RESPONSE TO REQUEST FOR ADDITIONAL INFORMATION

APR1400 Design Certification

Docket No. 52-046

RAI No.: 203-8214
SRP Section: 08.03.01 – AC Power Systems (Onsite)
Application Section: 8.3.1
Date of RAI Issue: 09/08/2015

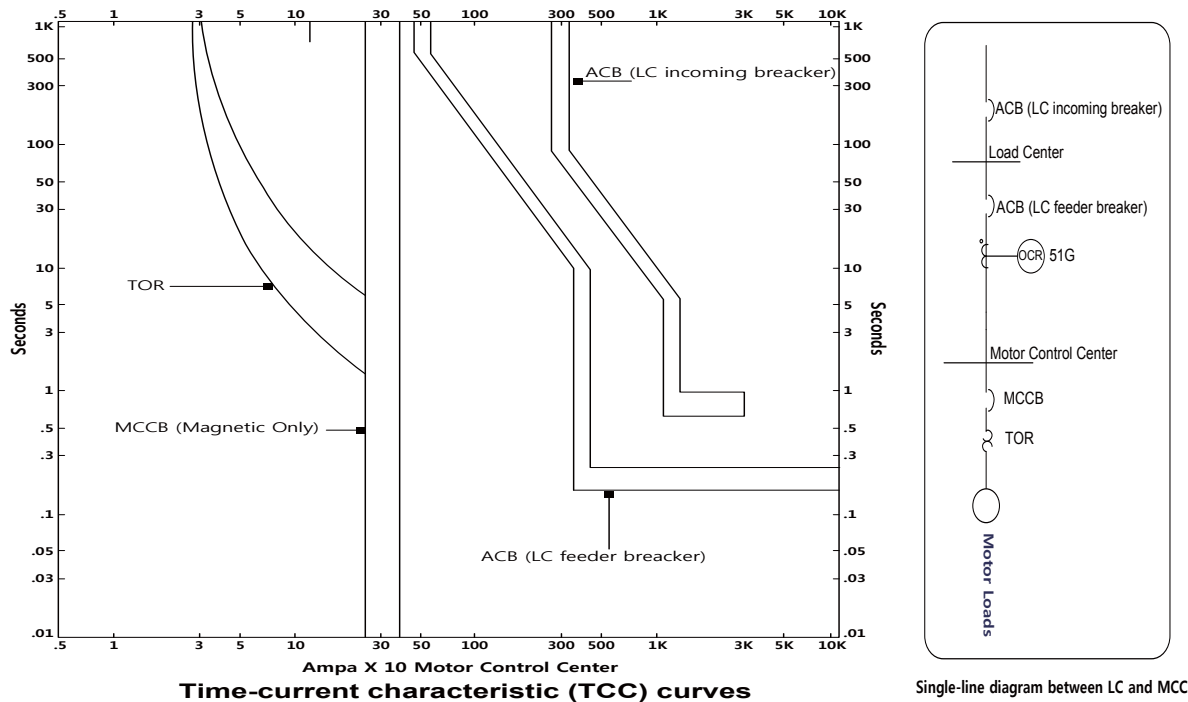
The single line diagrams, Figures 8.1-1 and 8.3.1-1, show one circuit breaker as the connector between the load center and the motor control center (MCC) as typical. GDC 17 states that onsite power systems shall provide sufficient capacity and capability in the event of postulated accidents. Please clarify why an incoming breaker (Main Disconnect) at the MCC is not provided for protection of the MCC. Otherwise, please discuss how protection of the MCC with selective protection coordination is achieved from electrical faults.

Selective protection coordination between 480V LC and MCC

The MO type MCCB or TM type MCCB provides primary protection for the MCC feeders with instantaneous and overload (with time delay) protection characteristics.

The ACB which has LT and ST trip elements of the overcurrent relay provides primary protection for the MCC main bus and also backup protection for the MCC feeders. The ACB protection elements are designed to properly coordinate with the primary protection of the MCCB such that the selective protection coordination precludes nuisance trips of the LC feeder breaker upon a trip at the MCC feeders. To illustrate the preceding, an example of the time-current characteristic (TCC) curves with a single line diagram between the LC and MCC is provided below.
